SERVICE BULLETIN

Classification: BT21-009	Reference: NTB21-082	Date: September 9, 2021
-----------------------------	-------------------------	----------------------------

REAR KICKING PLATE PART CHANGE

APPLIED VEHICLES: 2022 Pathfinder (R53)

Figure 1

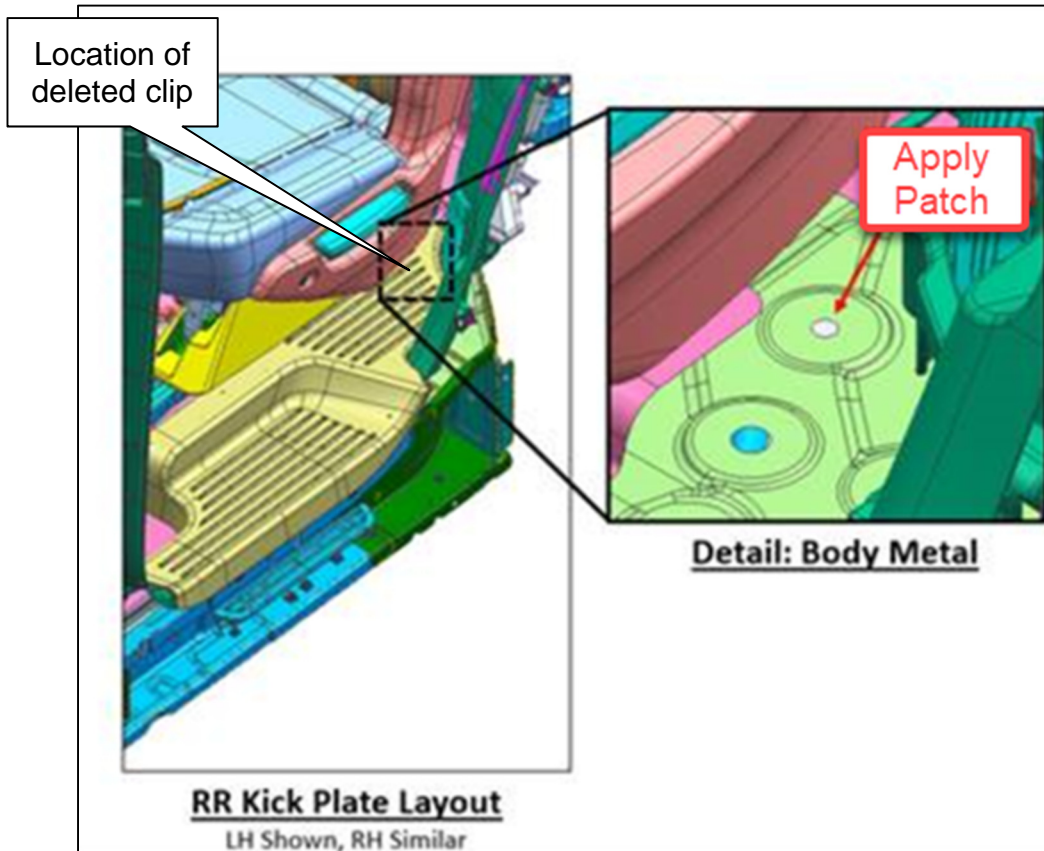
The rear kicking plates have been updated to delete a rear clip. If a rear kicking plate is being replaced, use the parts listed in the **PARTS INFORMATION** on page 2.

IMPORTANT: When replacing a rear kicking plate with an updated part, early production vehicles must have the hole for the deleted clip covered with a body patch (Figure 1), to prevent water intrusion.
